**Gatwick Airport Northern Runway Project – Development Consent Order (DCO)**

**Written Representations for Deadline 12<sup>th</sup> March**

**Gatwick Area Conservation Campaign (GACC)**

**12th March 2024**

Source: APP-251

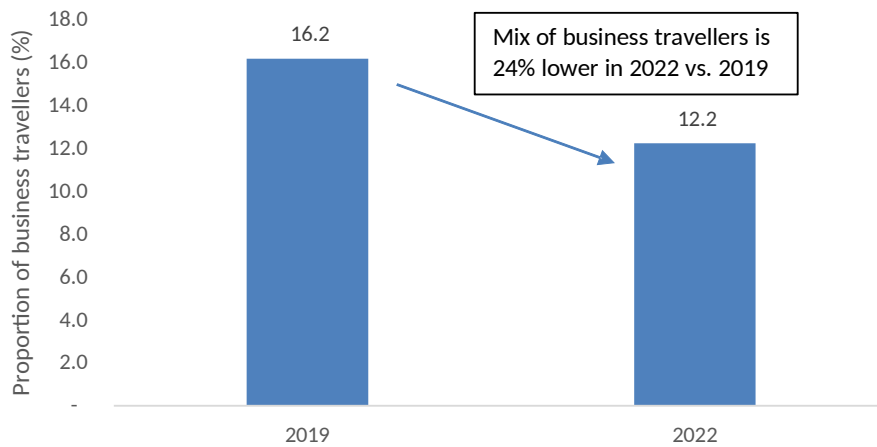
6. GACC reiterate concerns raised by NEF that the claimed level of benefit should be better evidenced as it does not appear credible. NEF (in their Losing Altitude report, 2023) note that nationally, business air passenger numbers peaked in 2006. A structural change took place following the 2007/08 financial crisis, which means total business passenger numbers have never recovered to the 2006 peak. There are strong indications that the Covid-19 pandemic has triggered a second structural shift, which has further reduced business demand. GAL's forecasts do not look credible.

7. This overstatement of passenger benefits due to business travel appears significantly overstated not least because it is based on the assumption "that the pandemic will not have an influence on passenger air traffic related to the expansion project in the long-run."<sup>1</sup>

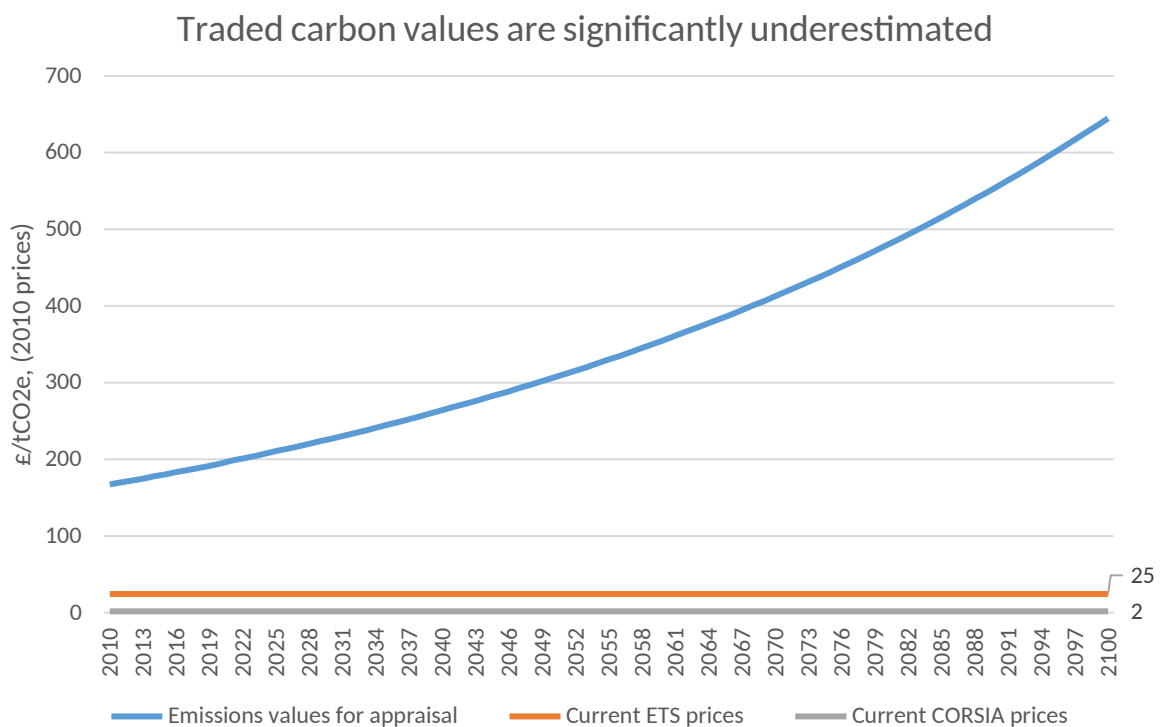
because the emissions values for use in appraisal significantly exceed the current carbon prices under the UK ETS and CORSIA, as shown in the figure below.

24. Furthermore, it is noted that non-traded aviation emissions include those operating under CORSIA, a carbon offsetting scheme, which Gatwick estimates to cover 10.5MtCO<sub>2</sub>e–11.6MtCO<sub>2</sub>e of emissions. These have been excluded from the assessment because they are also already included in fares. GACC shares NEF’s concern regarding how this figure for CORSIA-eligible emissions was arrived at. GACC would also point out the same methodological failing as applied to traded prices. The calculation should be the carbon values, less the price paid under CORSIA. A significant residual cost to society will remain after this calculation is completed.

25. Gatwick should revise its assessment to take into account the latest TAG guidance, and use the recommended TAG carbon appraisal values when valuing carbon emissions.
